ADDENDUM N0. 1

HERNDON STATION METRO GARAGE
CONTRACT NO.CN16100006
PROJECT NO. TF-000020-001

This addendum is supplementary to the contract documents for the Herndon Station Metro Garage in Herndon, Virginia.

SITE PLAN WITH EXISTING SUNRISE VALLEY DRIVE

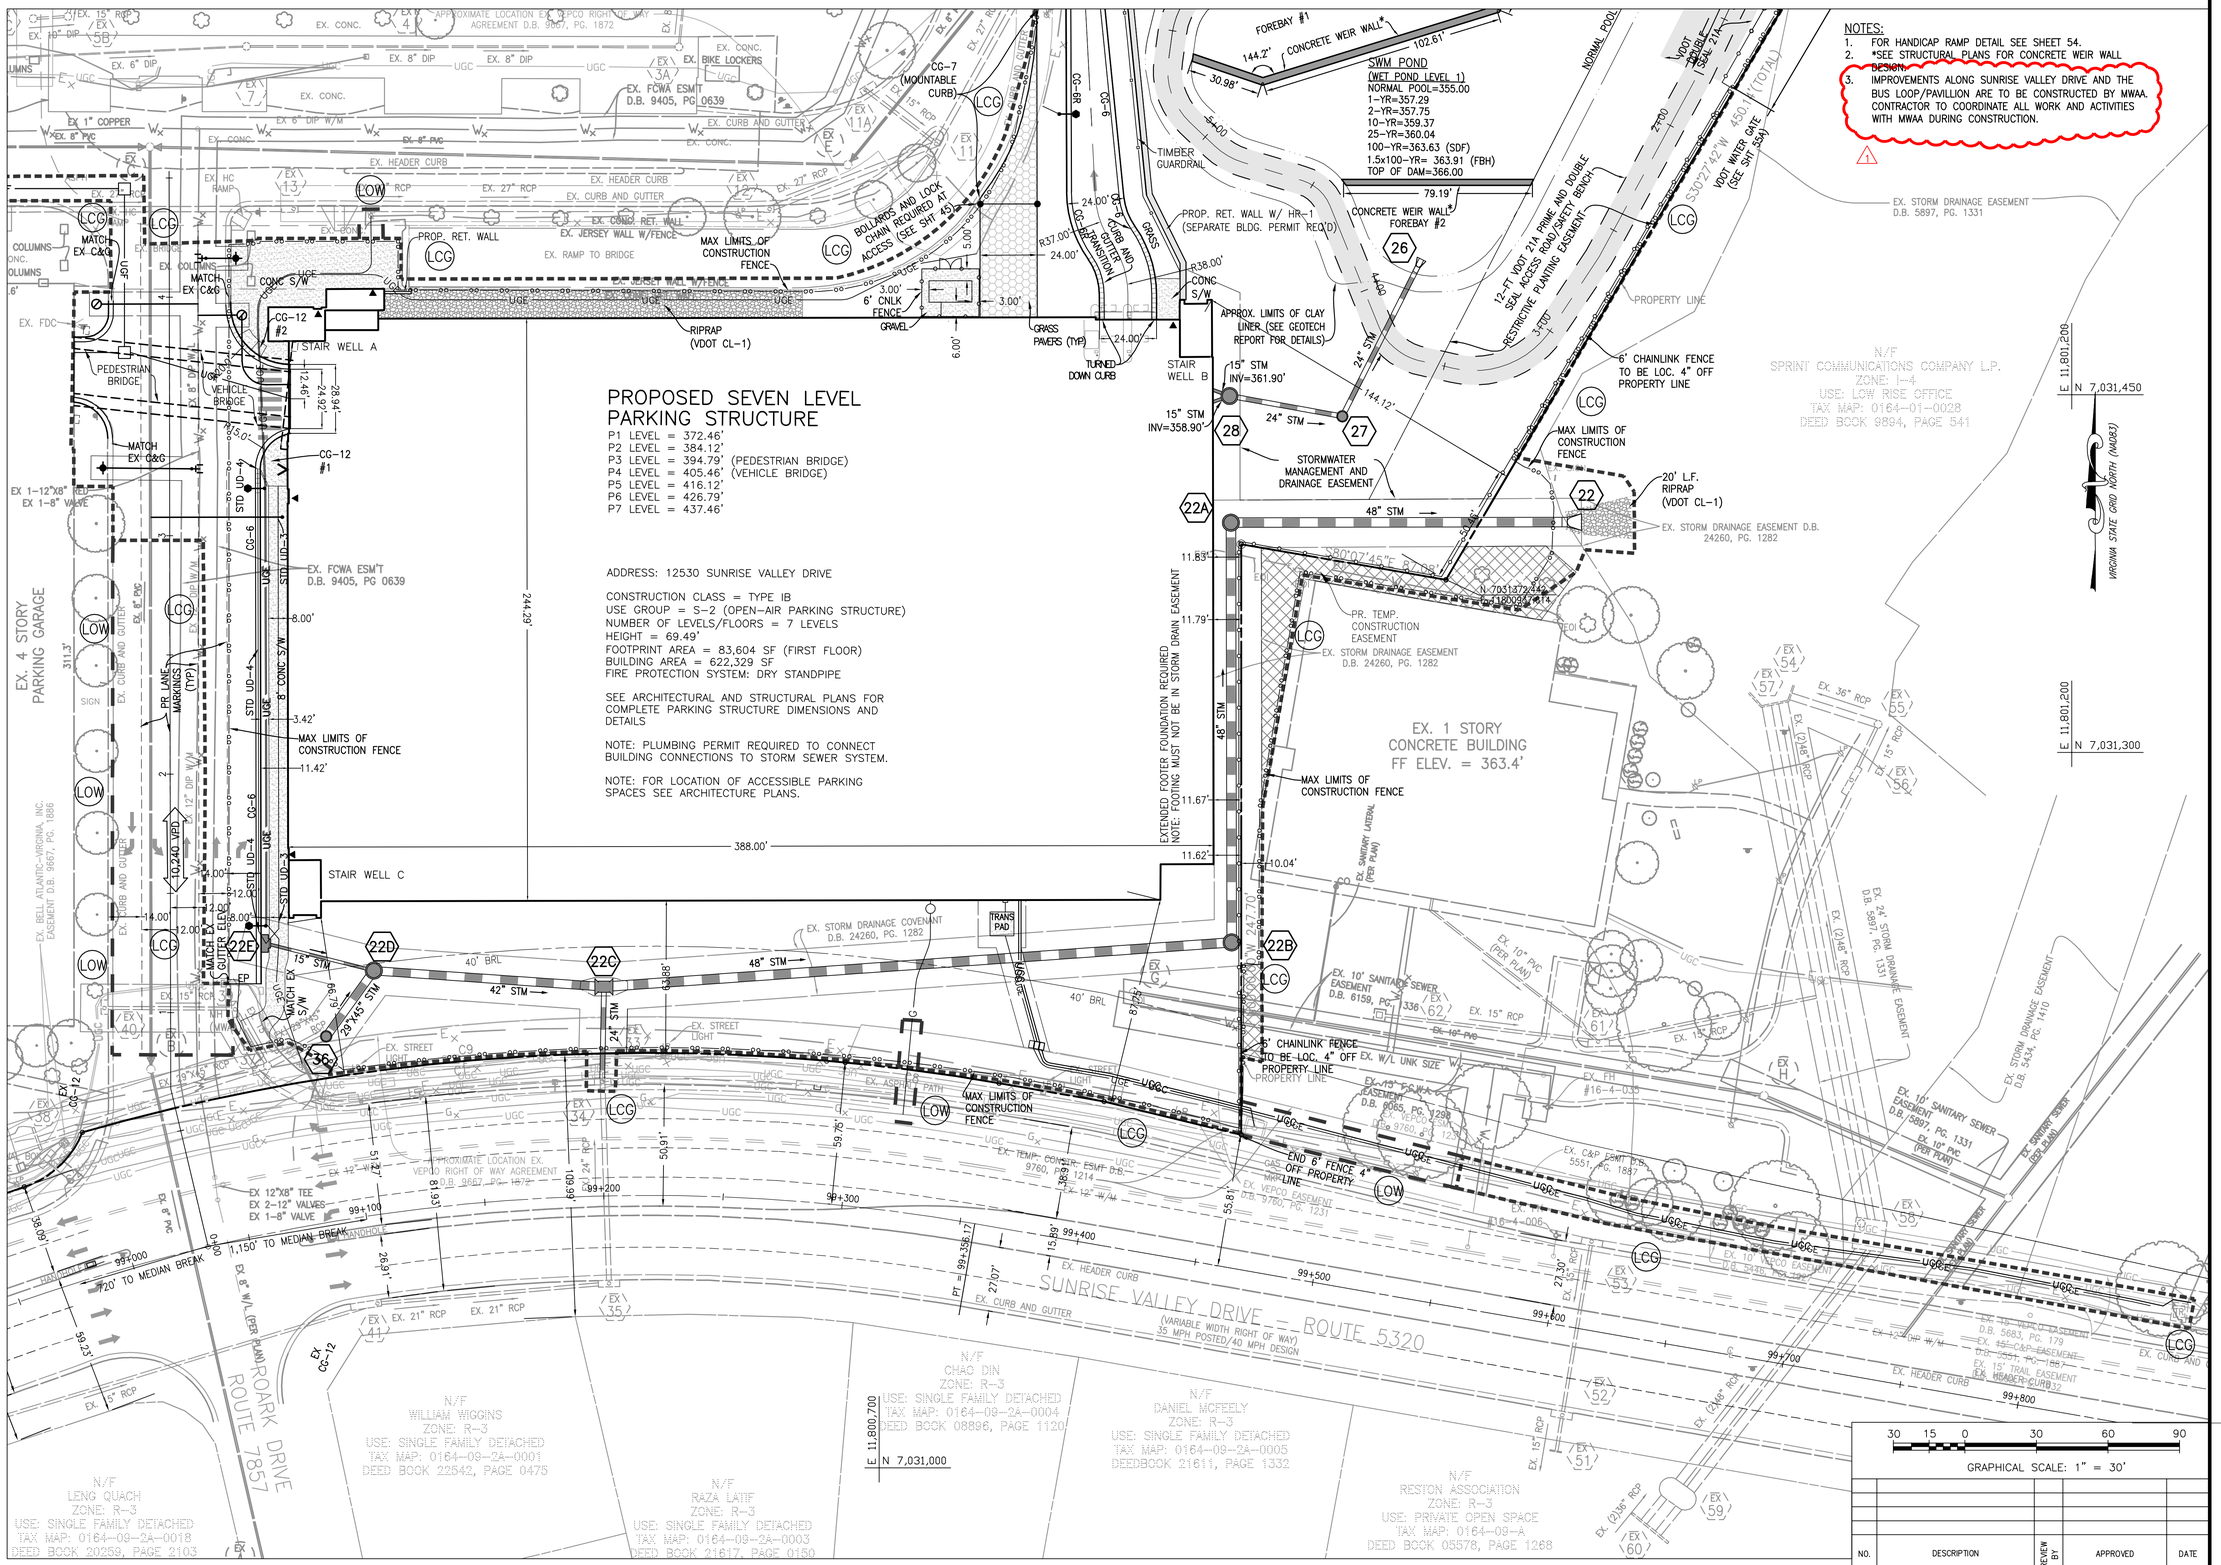
DRAWINGS	
1.3	10A of 61	Added note to Coordinate all work and activities with MWAA during construction.
1.4	12A of 61	Added note to Coordinate all work and activities with MWAA during construction.

UTILITY PLAN WITH EXISTING SUNRISE VALLEY DRIVE

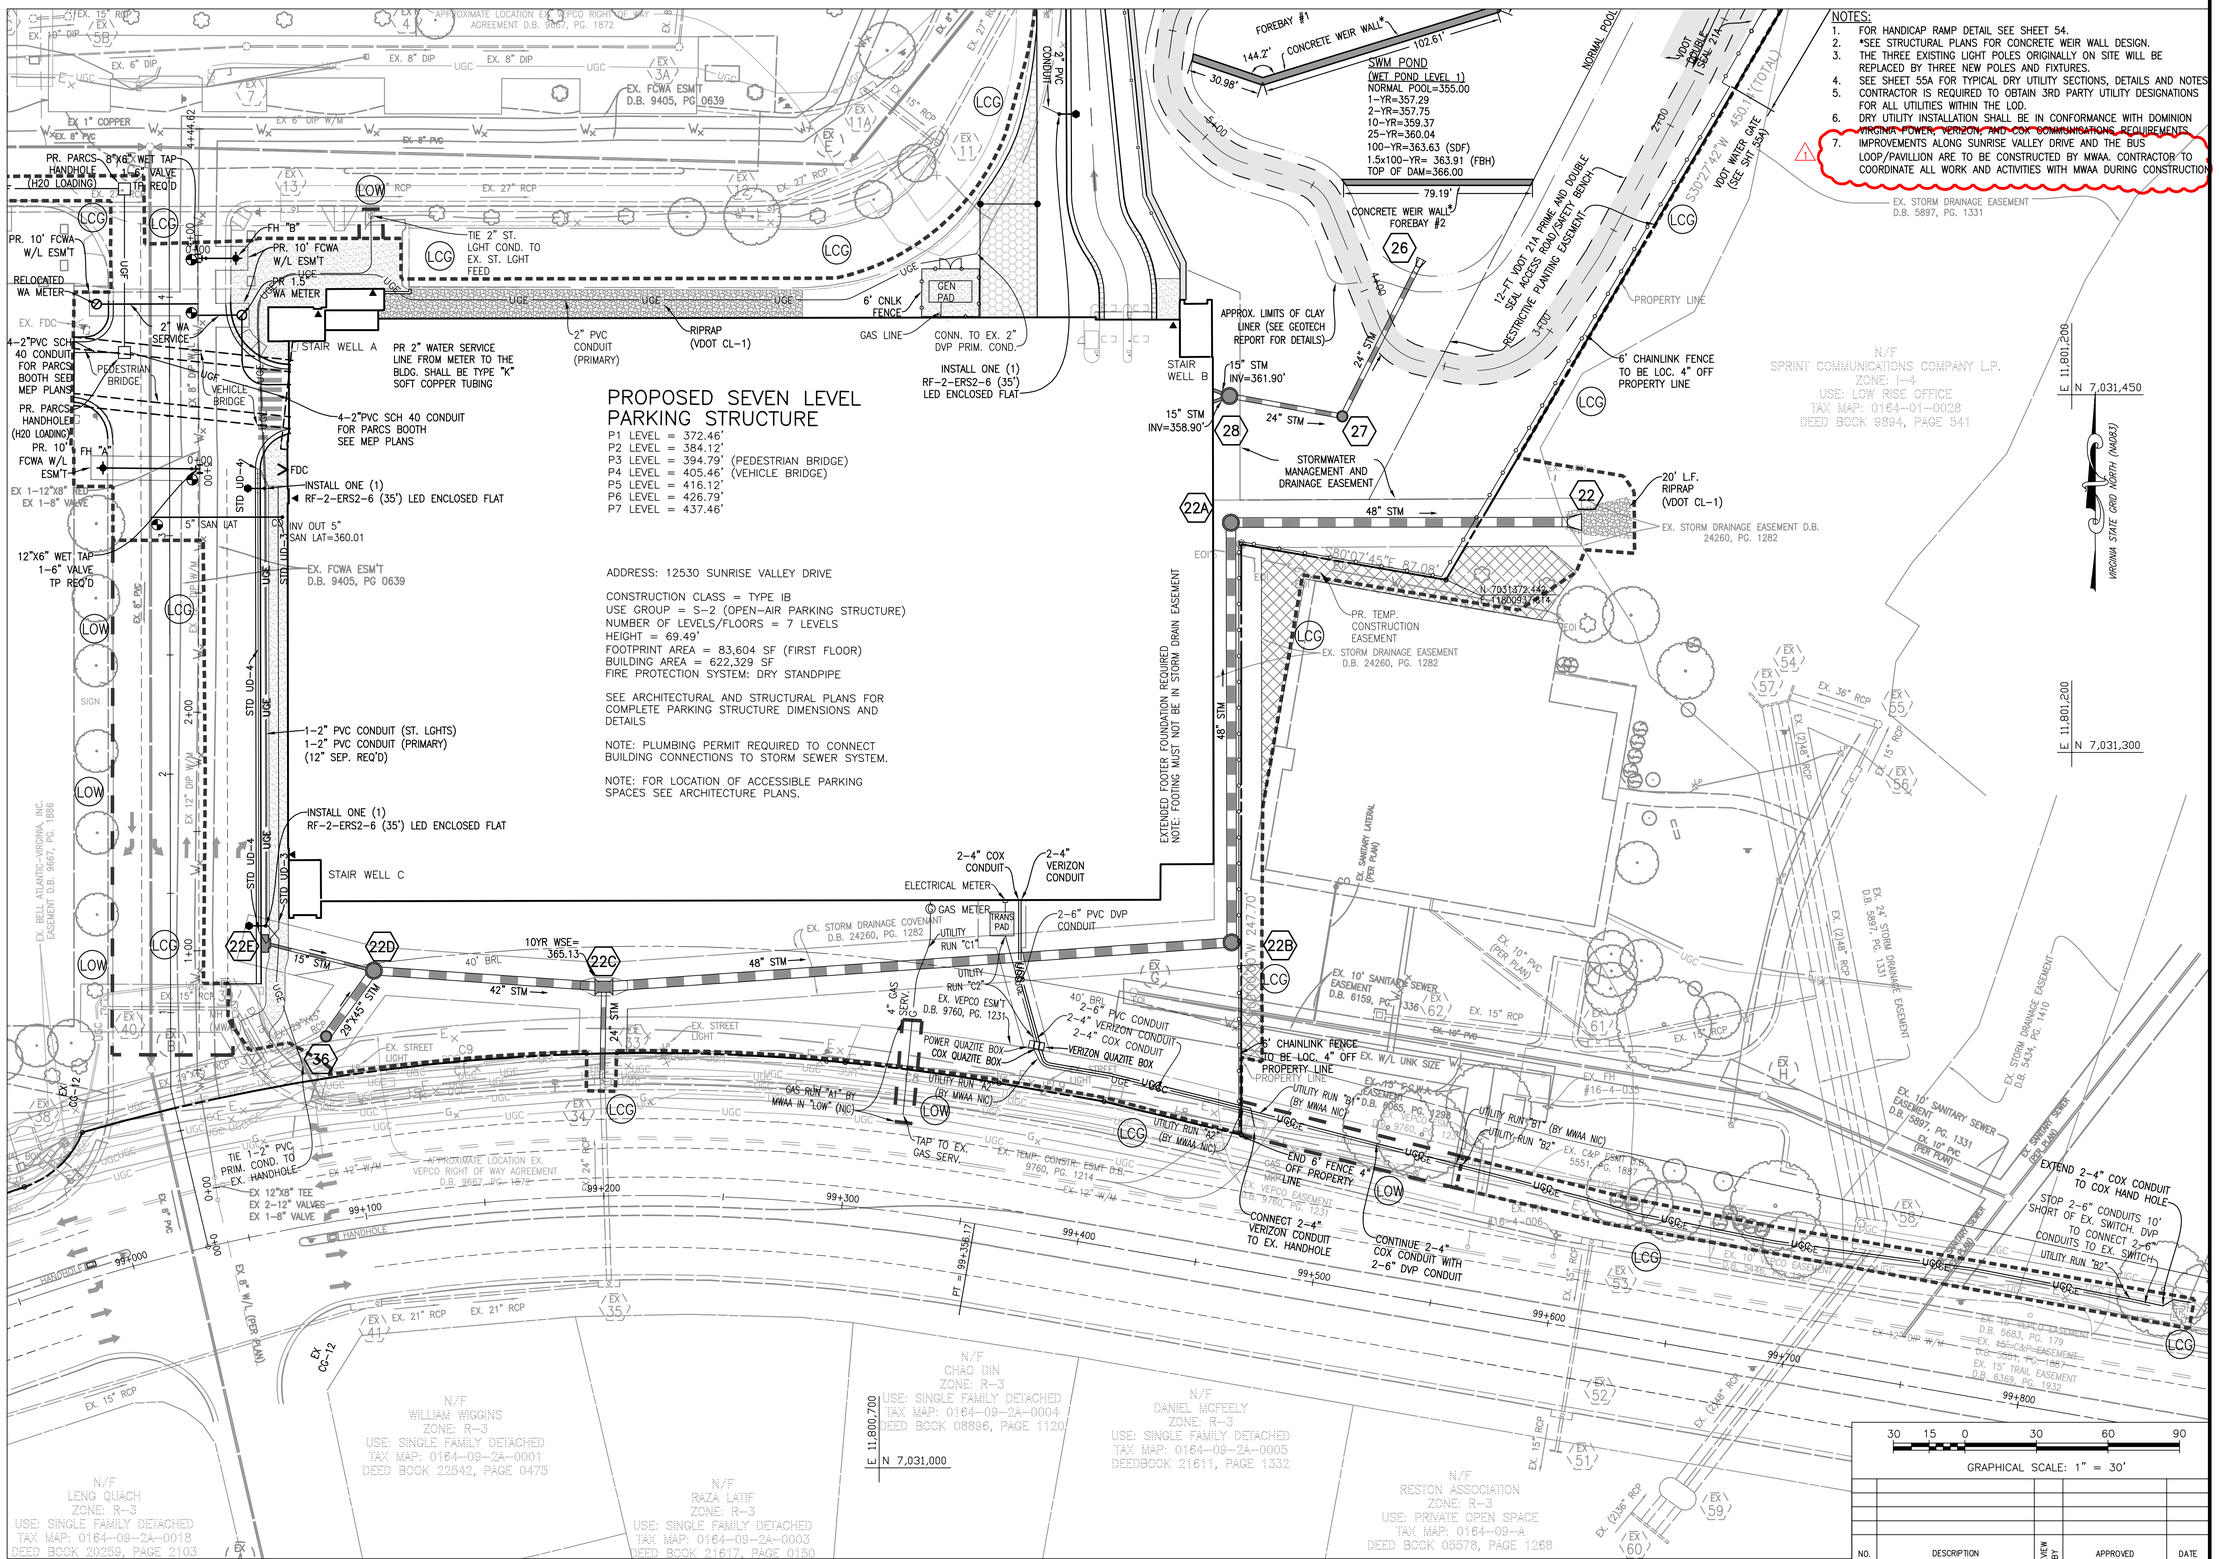
1.5	13A of 61	Added note to Coordinate all work and activities with MWAA during construction.
1.6	15A of 61	Added note to Coordinate all work and activities with MWAA during construction.

TEMPORARY NORTHERN EGRESS GRADING PLAN WITH EXISTING BUS LOOP

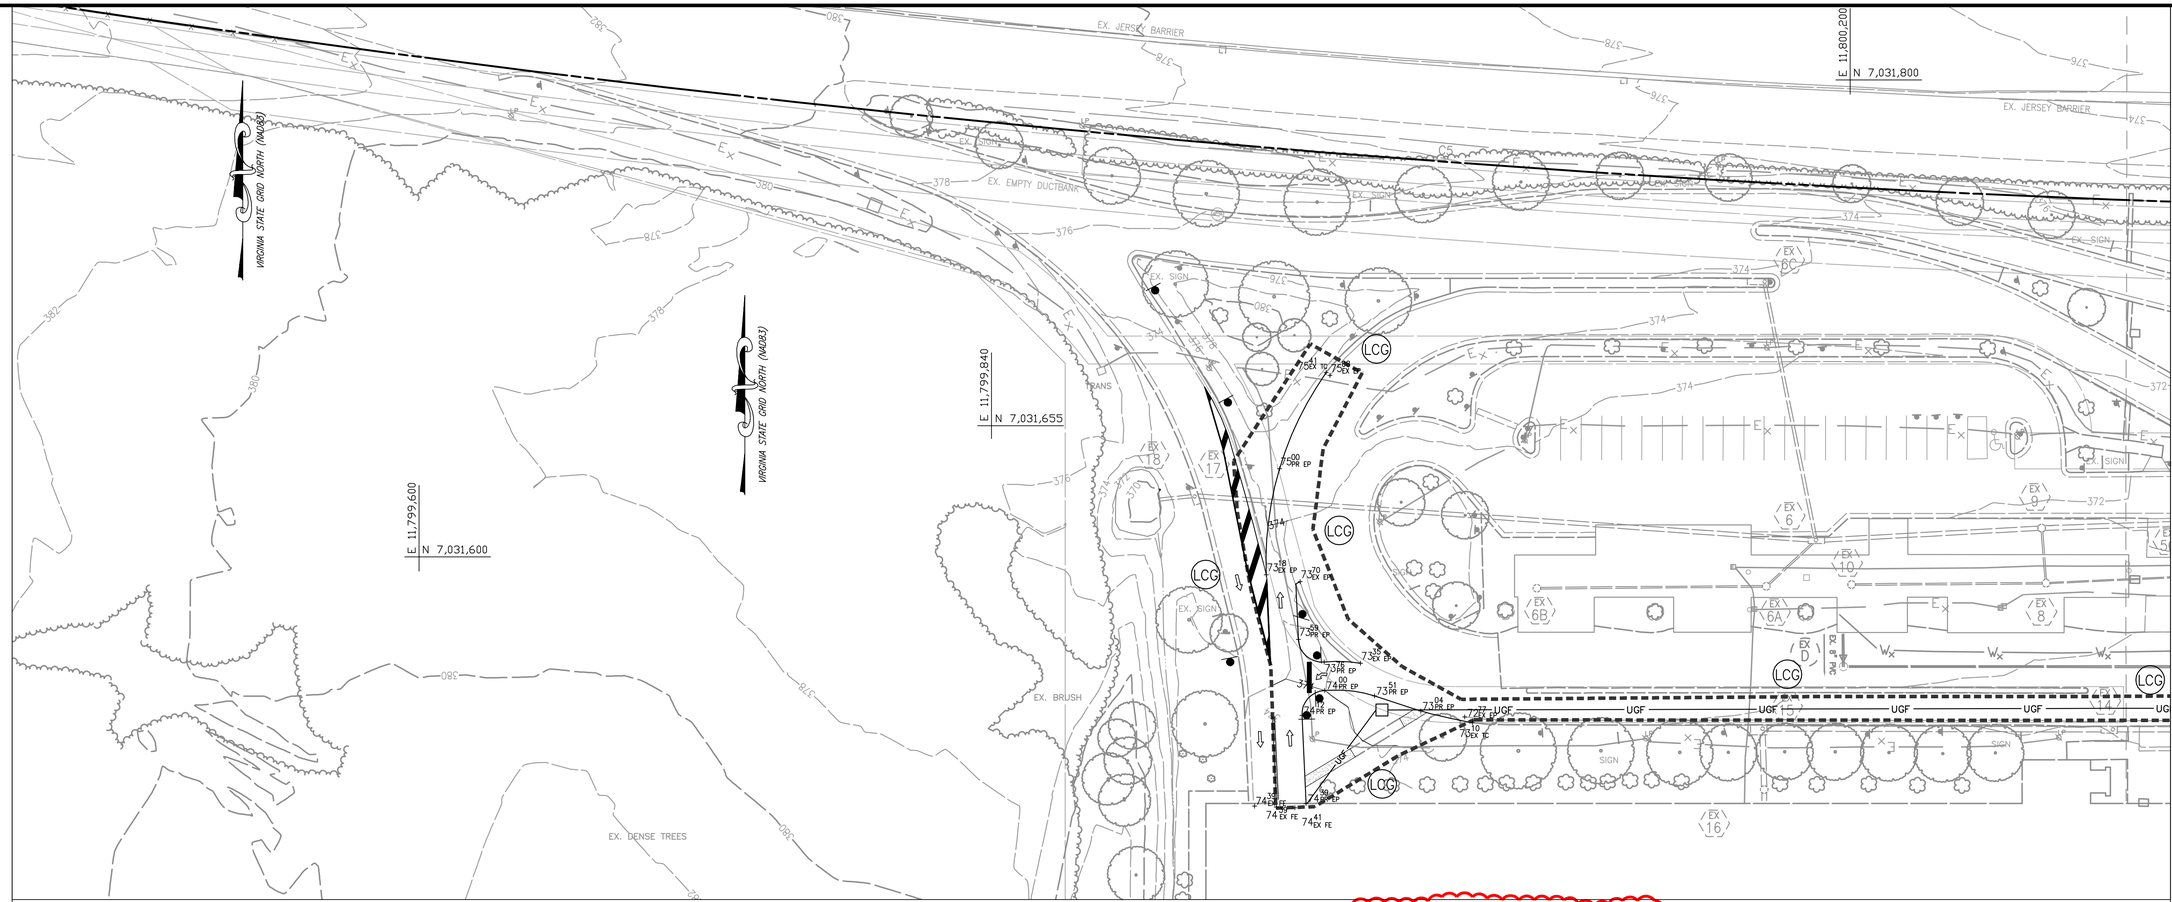
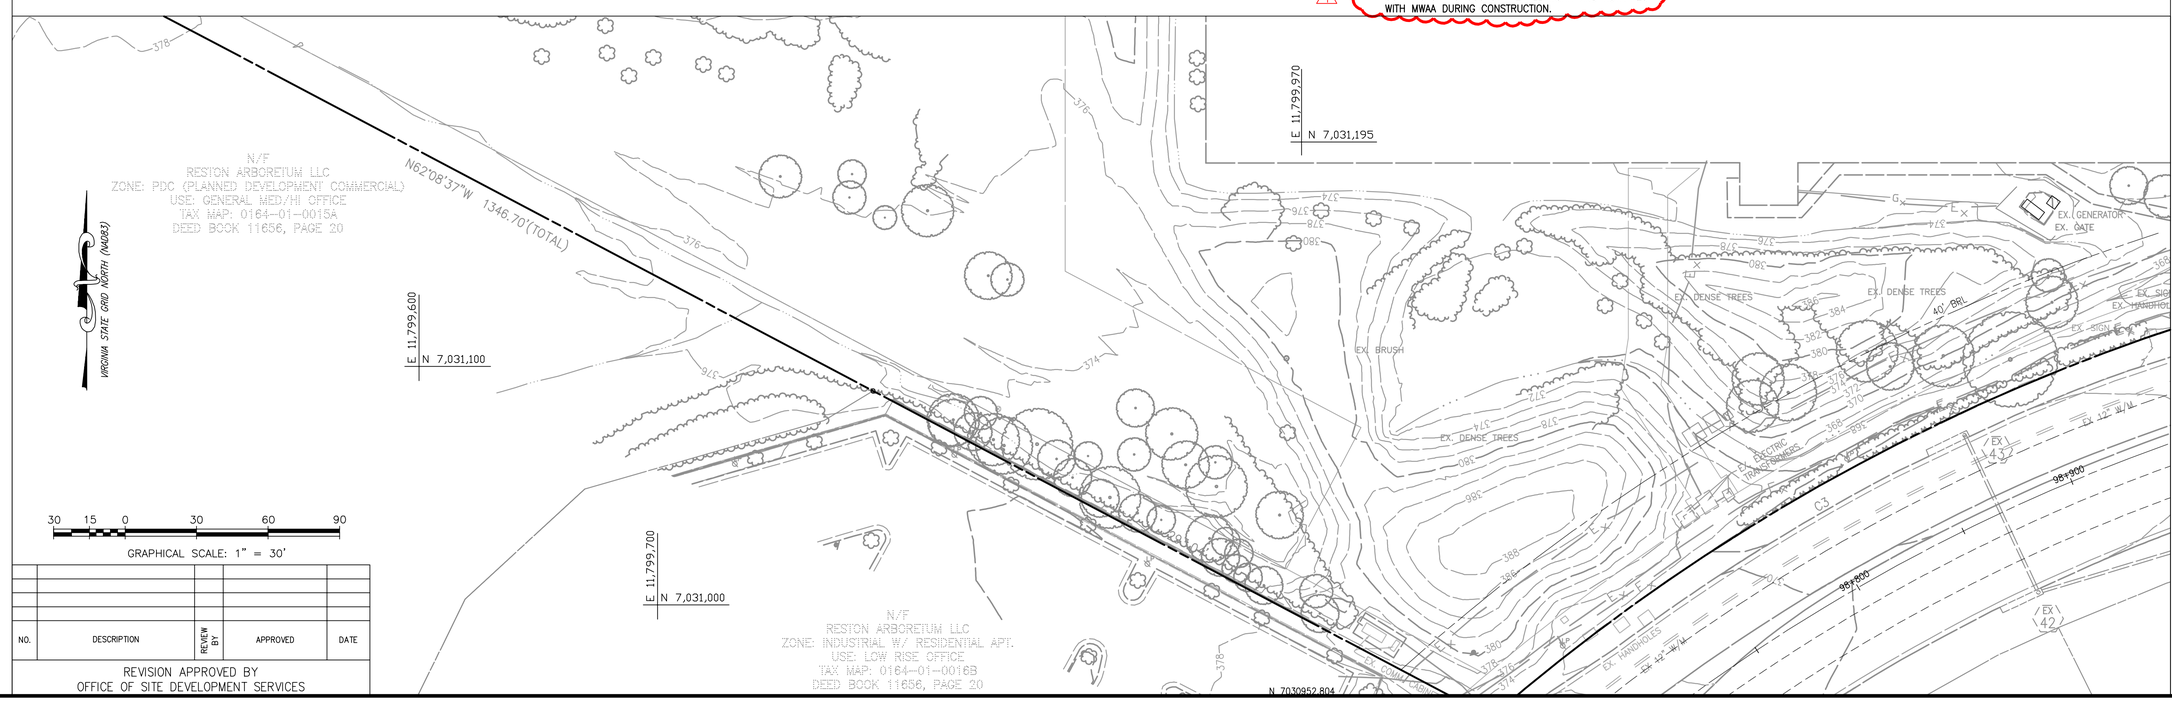
1.7	16A of 61	Added note to Coordinate all work and activities with MWAA during construction.
1.8	18A of 61	Added note to Coordinate all work and activities with MWAA during construction.

10 OFFICE FCDOT - NORTH ELEVATION
1/4" = 1'-0"

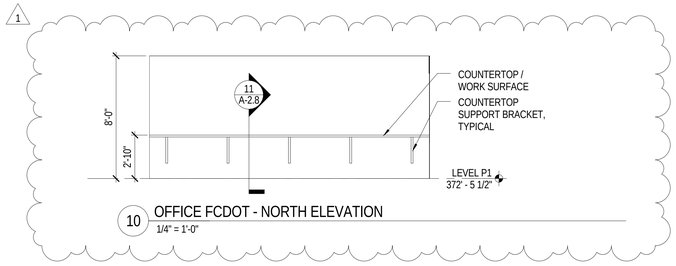
1.9	A-2.8	Added millwork details 10 and 11.
1.10	A-4.7	Added millwork counter to room 107 FCDOT Office.
1.11	PK-2.01	Revised demo note to refer to SD sheets. Note revised in two locations.
